Title & Document Type: **8405A Vector Voltmeter Operating and Service Manual**

Manual Part Number: **08405-90024**

Revision Date: **May 1971**

8405A

Figure 7-13(b). Schematic Diagram, Voltmeter

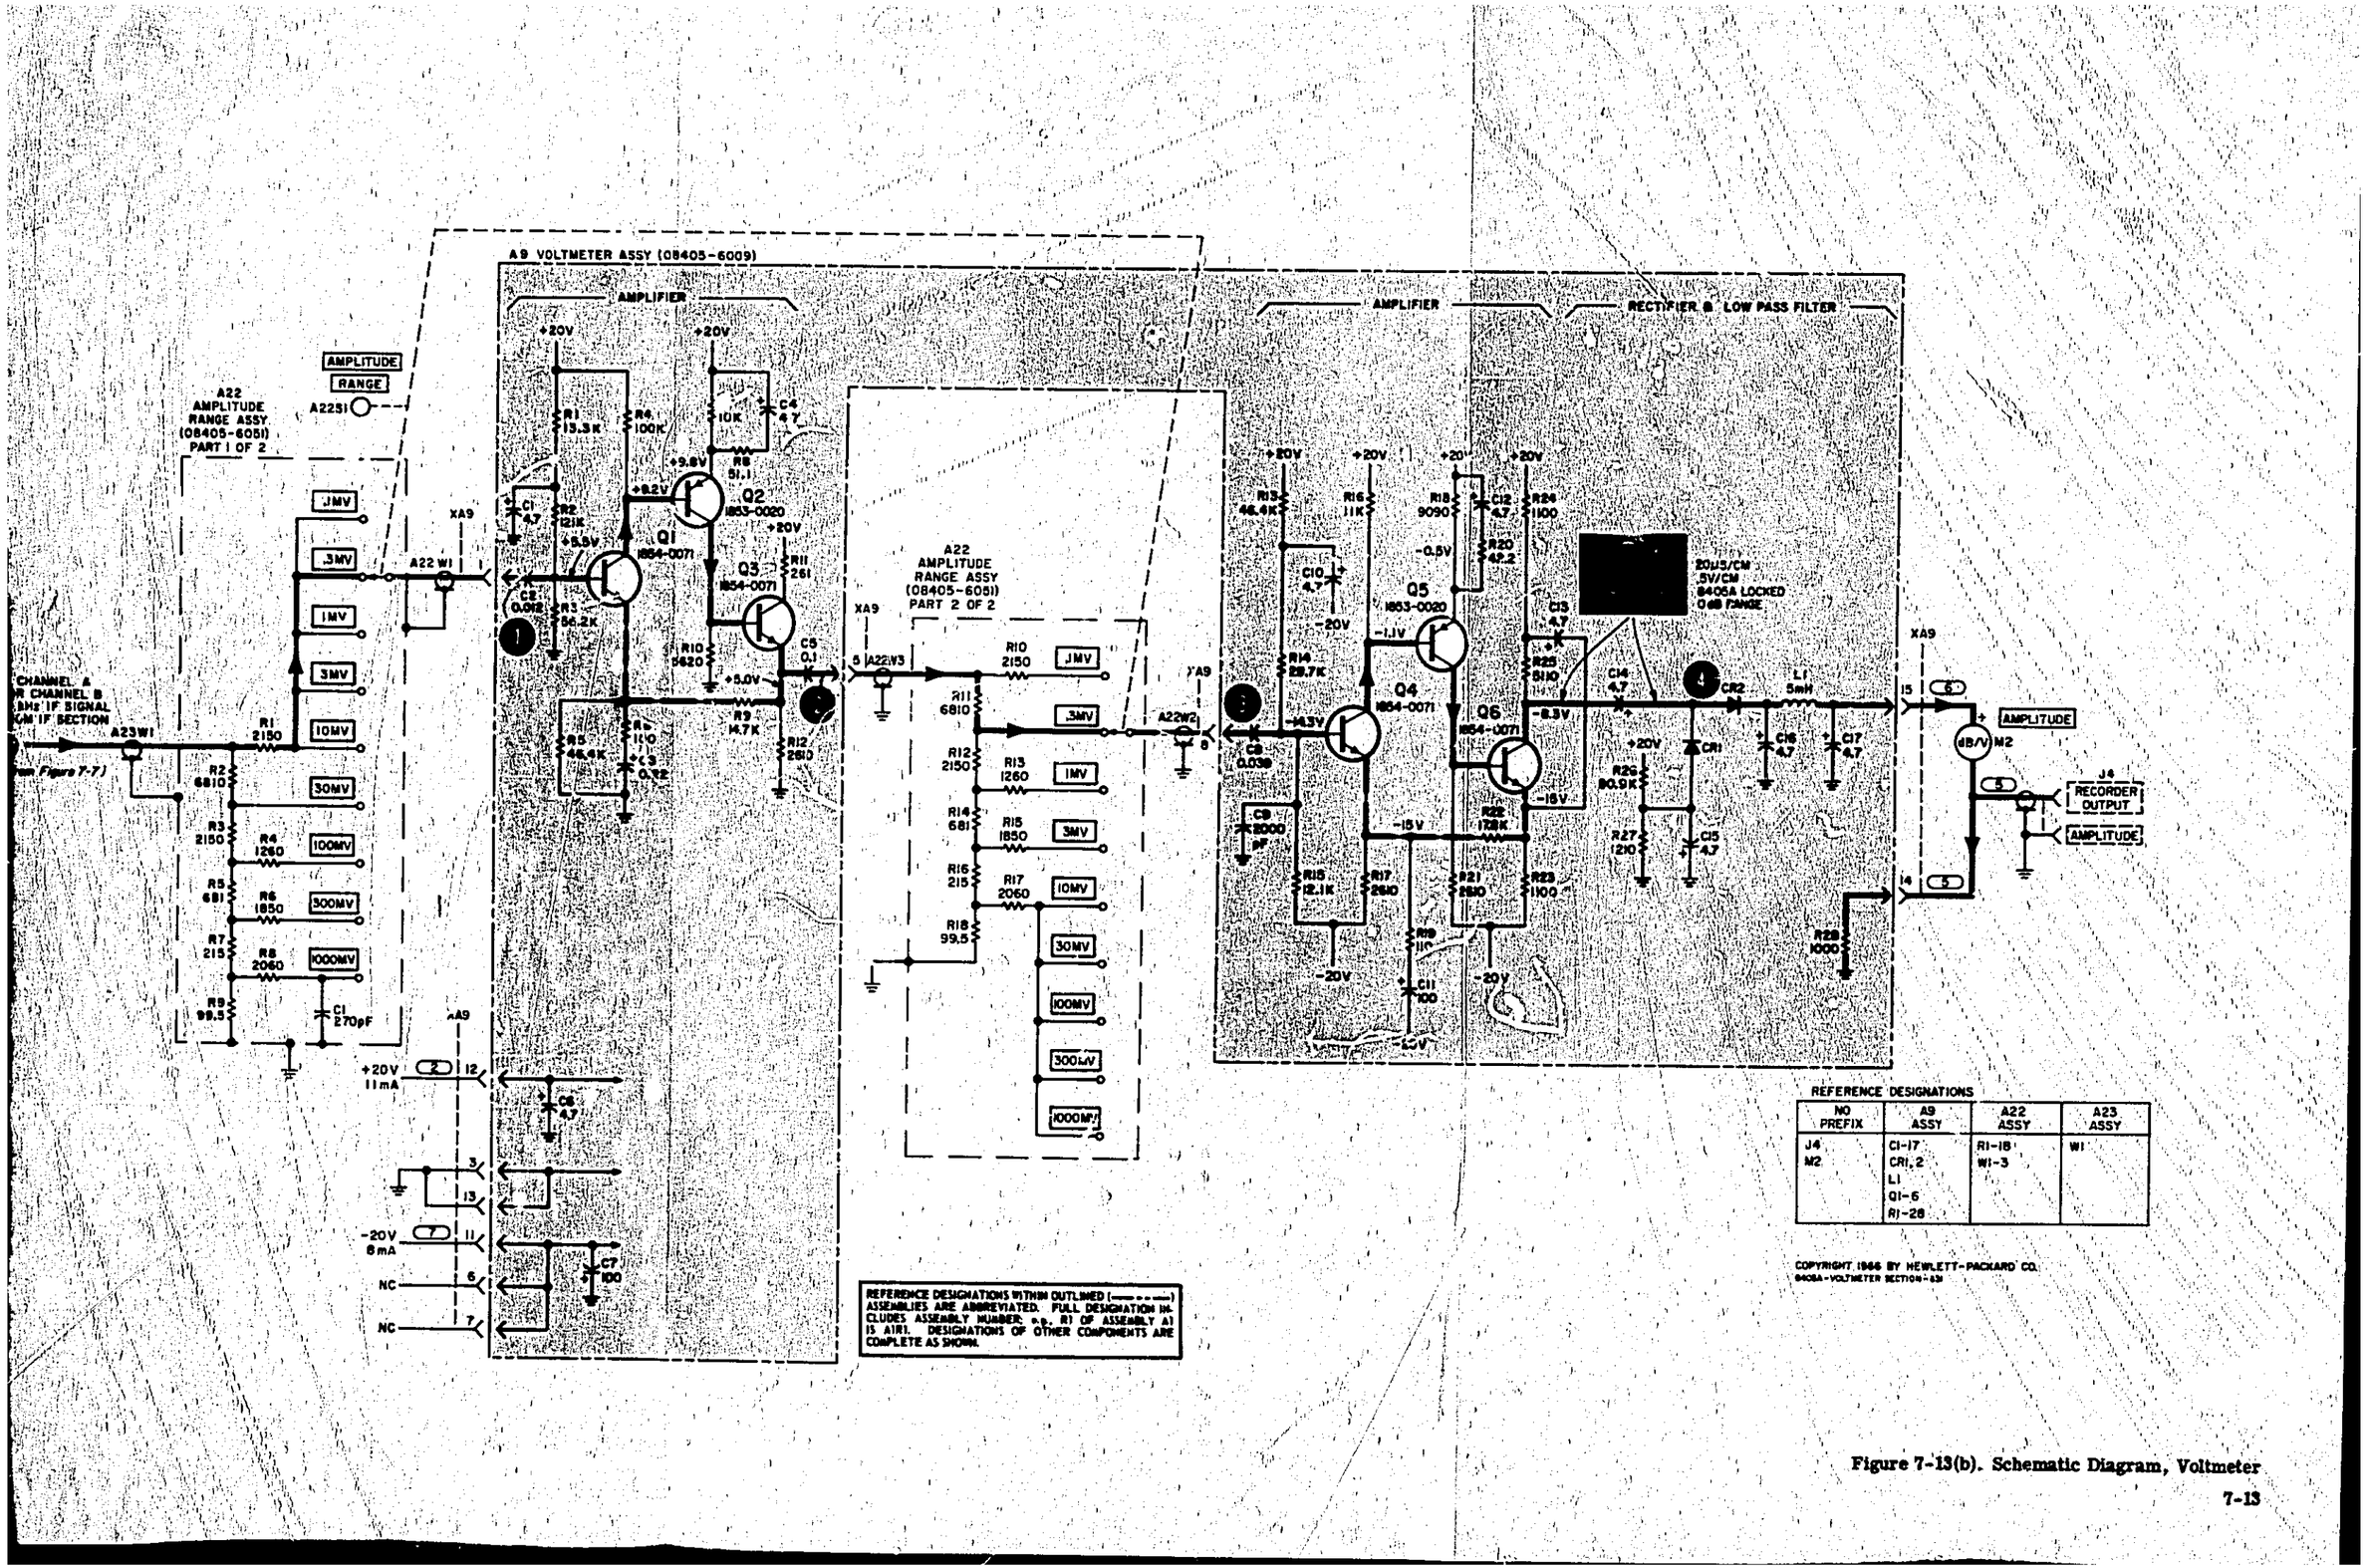
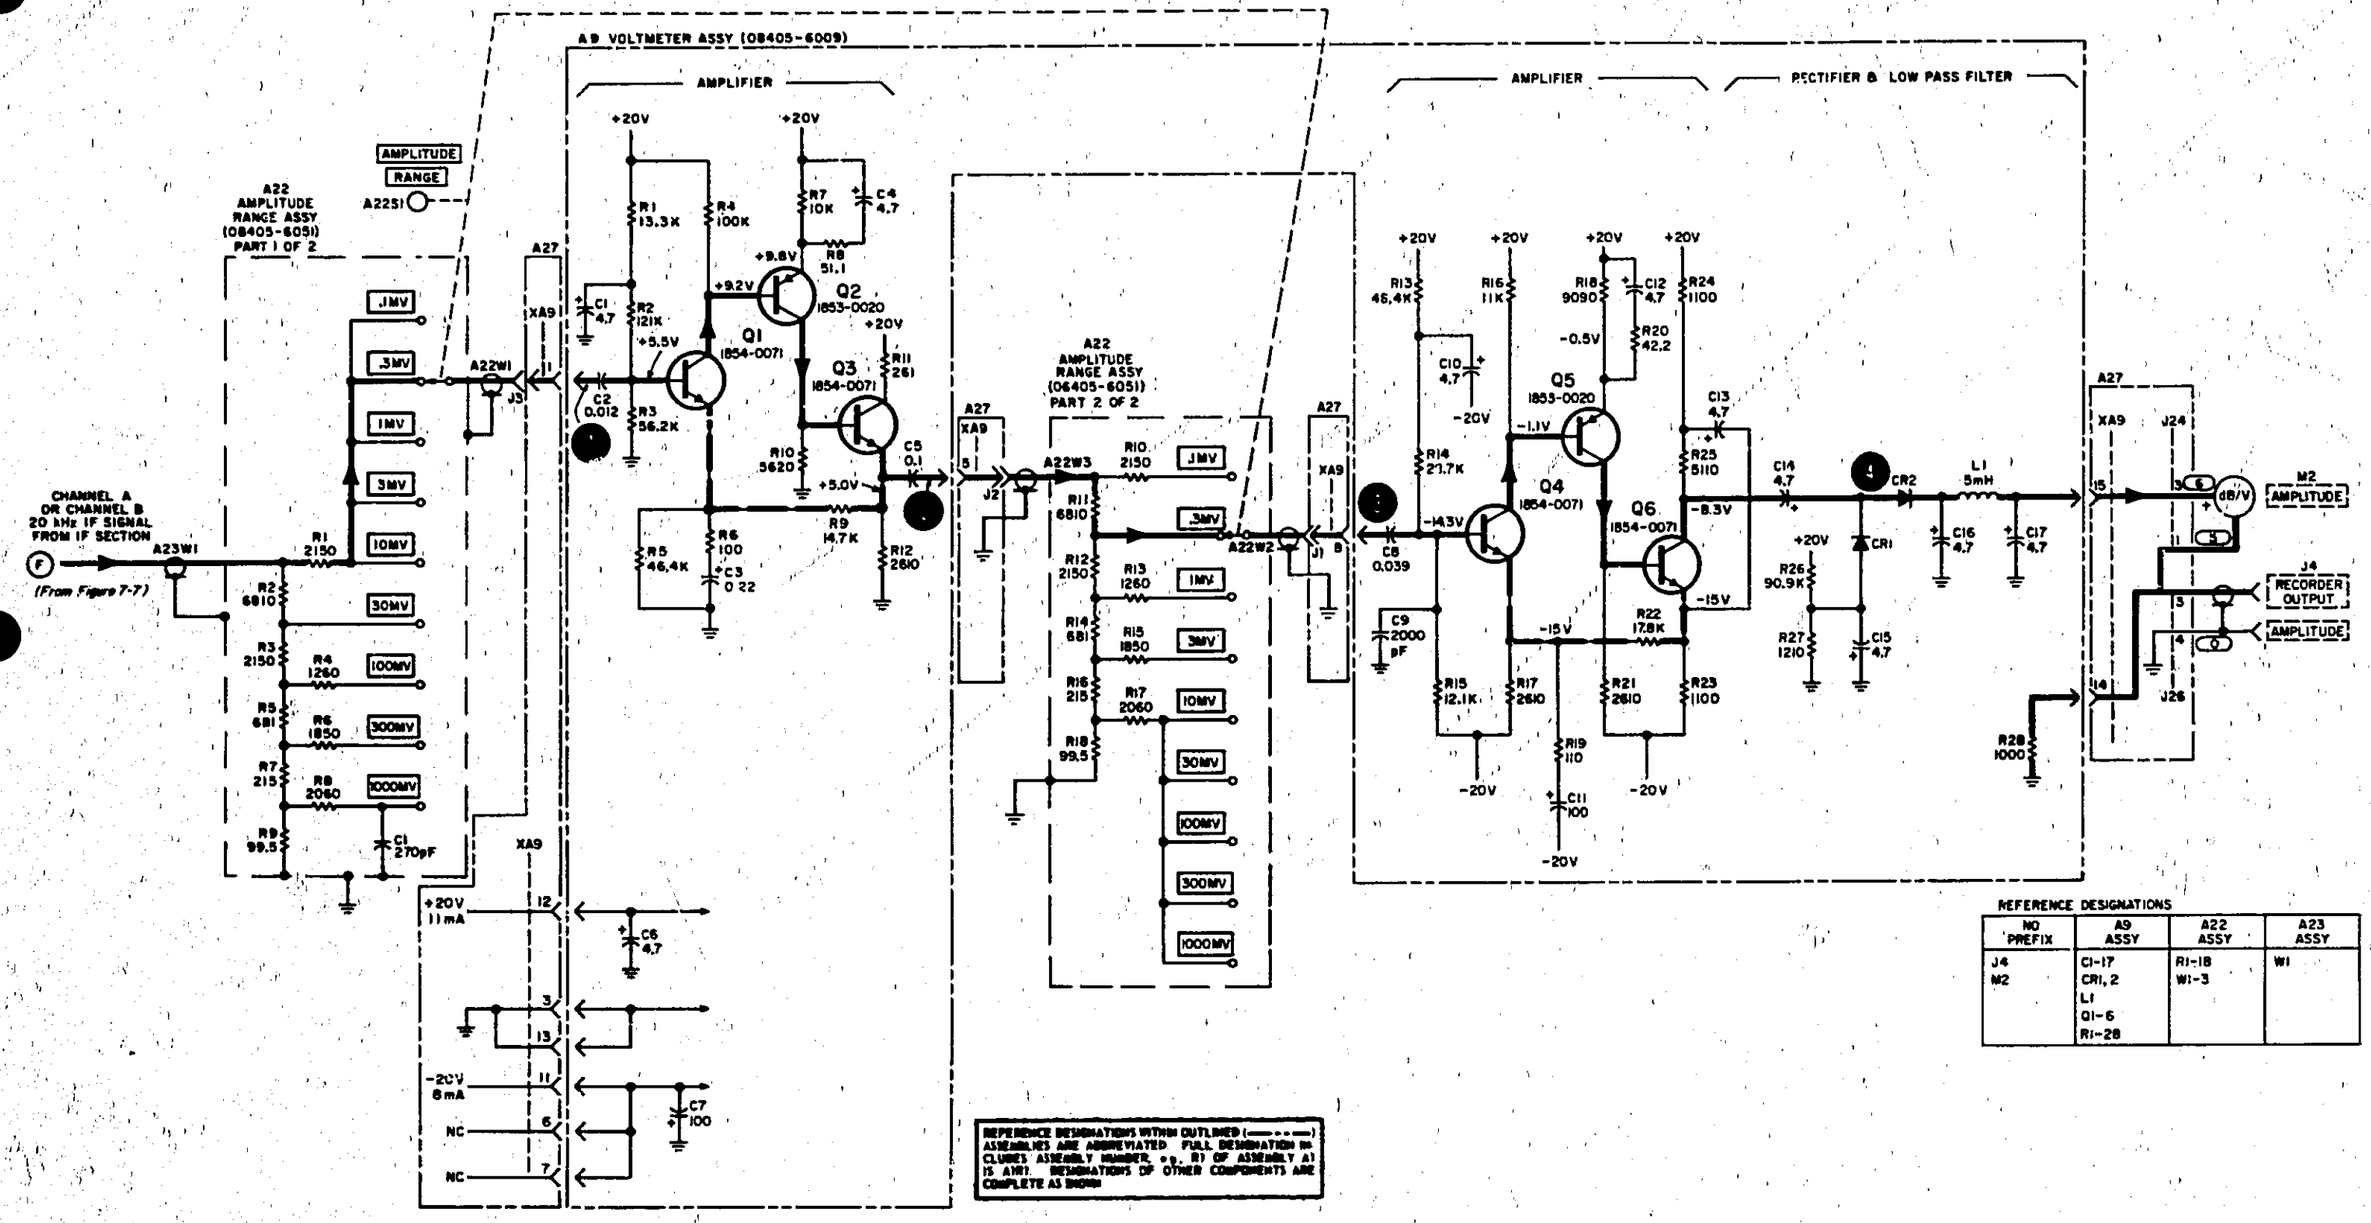
Change Figure 7-13(b) of Change 17. The A22 Amplitude Range Assy is identified twice as part number 08405-6051. Replace the part number with this note: See Table 6-1 for current assembly number.

►PAGE 7-13:
Figure 7-13(a) and 7-13(b):
Change A9Q2 and A9Q5 to part number 1853-0389 (recommended replacement).

PAGE 7-13:
Figure 7-13(b):
Change Figure 7-13(b) of Change 17. The A22 Amplitude Range Assy is identified twice as part number 08405-6051. Replace the part number with this note: See Table 6-1 for current assembly number.

Replace Figure 7-13(b) with Figure 7-13(b) in this change sheet (CHANGE 17).

Figure 7-15(b). Schematic Diagram. Automatic Phase Control Section (Part 1)

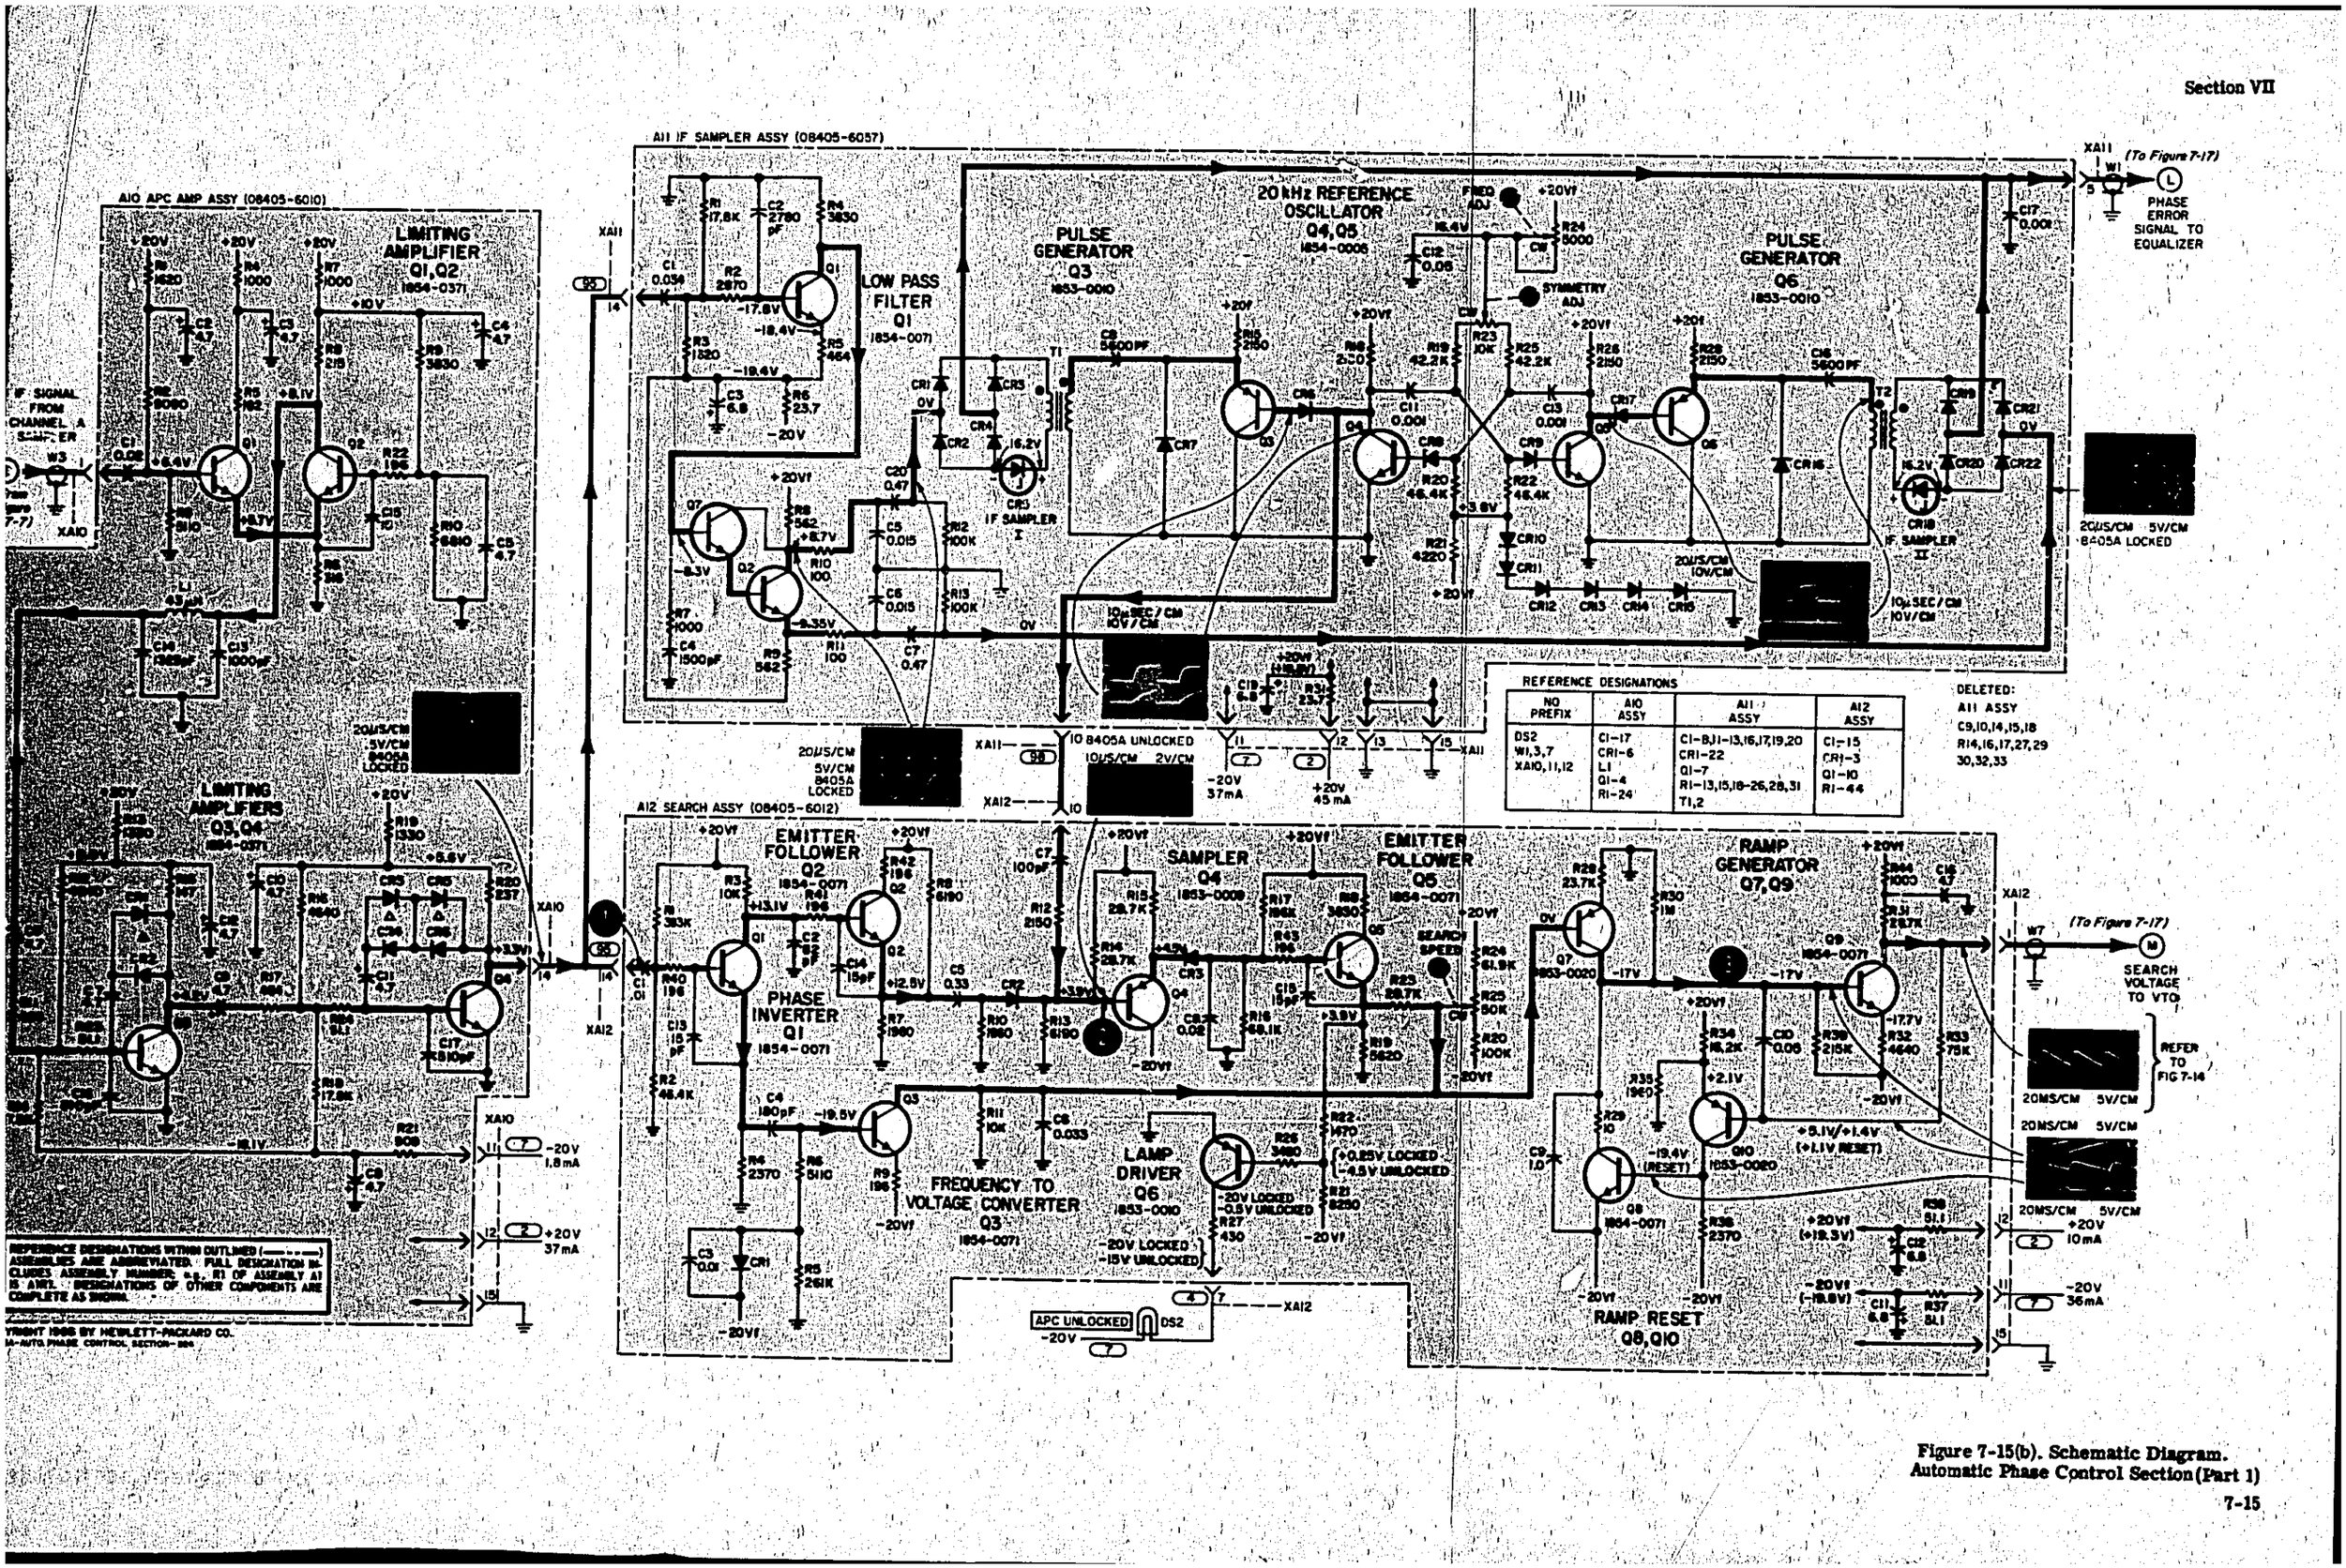
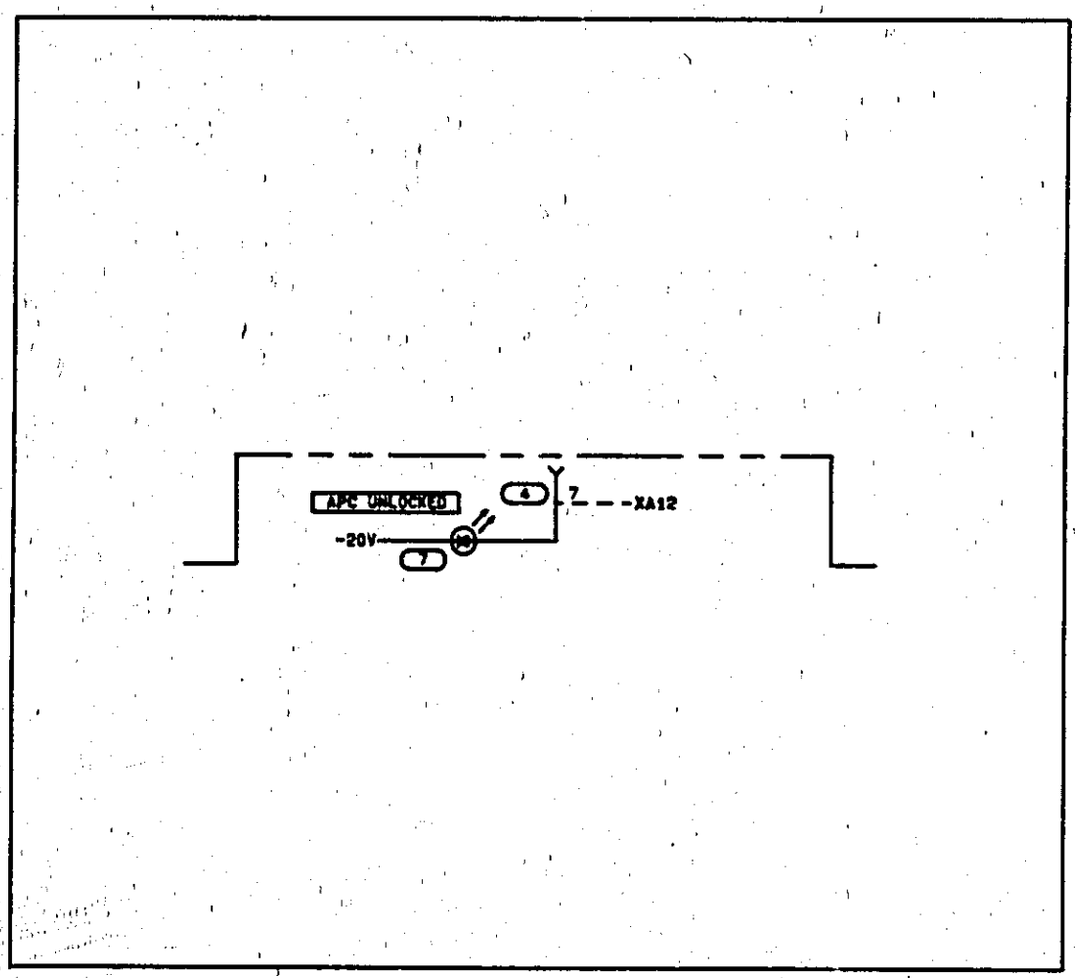
Change the A12DS2 symbol using the partial schematic in this document [P/O Figure 7-15(b) (CHANGE 11)].

Replace Figure 7-15(b) with Figure 7-15(b) in this change sheet (CHANGE 17)
